Willis Lake Access

Town of Sudbury ADA Transition Plan

September 2020

Institute for Human Centered Design

Figure 1: Based on Department of Conservation and Recreation (DCR) Pocket Guide. Suggested method of designating an accessible parking space and access aisle in an unpaved parking lot.

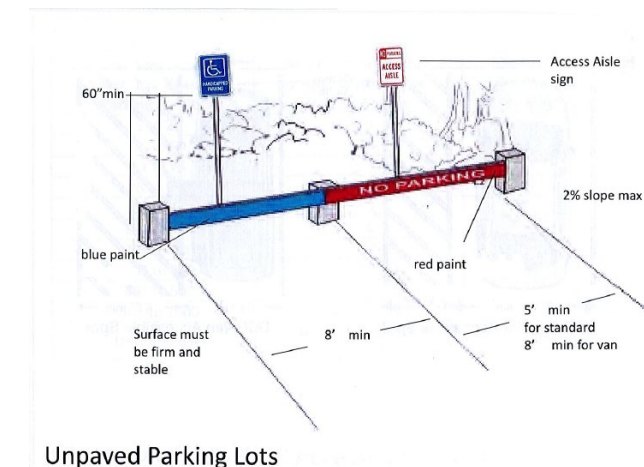
Accessibility issues include lack of a van accessible parking space with a marked access aisle, identification sign with the International Symbol of Accessibility (ISA), and a sign with the designation "Van Accessible". (See Figure 1 for a recommendation for marking the space and access aisle in an unpaved lot.)

| ID | Location | Floor | Room | Element | Type | Photo | Issues | Current Measure | Recommendations | Quantity | Price | Cost Estimation |
|---|-----------------------------------|-------|------|----------------------------------|----------|--|---|----------------------------|---|----------|-------|-----------------|
| 5 | Parking Area Near Dock | Ext. | | Off-Street Parking Lot or Garage | N/A |  | Total # of parking Total # of designated accessible parking spaces Total # of designated van accessible spaces Access aisle not provided Sign not provided Sign does not have the designation "Van Accessible" | 5 - - - - - | Provide a compliant van accessible parking space with a marked access aisle 60" wide min. and no steeper than 1:48 (2.08%) in all directions. Provide a sign with the International Symbol of Accessibility (ISA) located 60" min. and 96" max. above the ground. Add the designation "Van Accessible" to the sign located at the van accessible space. | 1 | 1850 | \$1850 |
